MEMORANDUM

From:	Stuart Ryder Landscape Architect Consultant		
Service	WBC Landscape and Trees	App No:	251608
Address:	Hennerton Golf Club, Crazies Hill, Wargrave, RG10 8LT.		
Proposal:	Full application for the proposed replacement of existing 10m high driving range netting with 15m high netting.		
Type of Development:	Minor All other developments		
Site Visit Made:	No

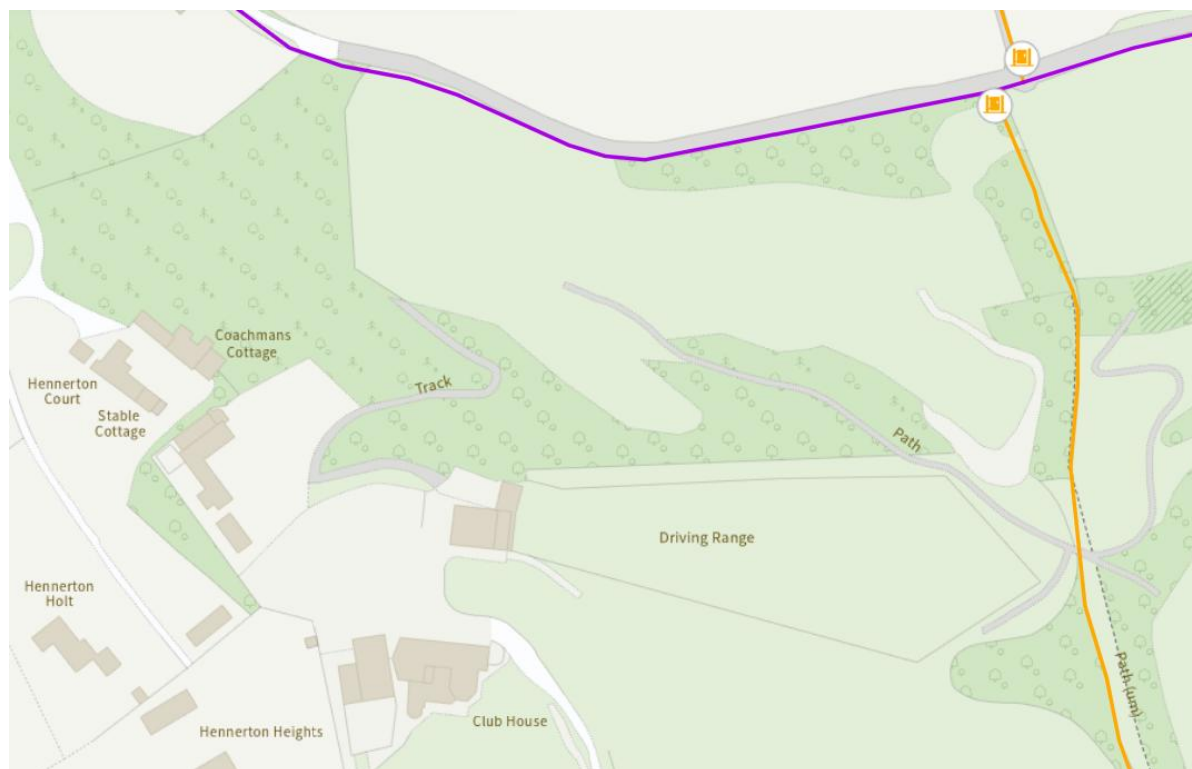
- However the Planning Statement fails to mark the position of Public Footpath WARG21 that is set an estimated 15m away from the pointed eastern end of the range – please see digital extract from WBC online PRoW Map below with WARG21 marked by the orange line and Penny Lane Bridleway by the purple route.

- The driving range will likely be visible from Footpath WARG21 but given that there is already one there and in the consciousness of path users its increase height will have limited effects on the enjoyment of their walk.
- It would be useful to receive a site photograph from Footpath WARG 21 to understand how much of the driving range is visible from it and the impression of the existing 10m end stanchion.
- The Planning Statement also fails to recognise that this part of the Borough is in the Remenham Chalk Area of Valued Landscape as defined in the Wokingham Valued Landscape Assessment – September 2024.
- If this was a new feature that was not associated with an established golf course landscape then the change to landscape character would lead to an objection given the sensitivity of the contextual landscape.
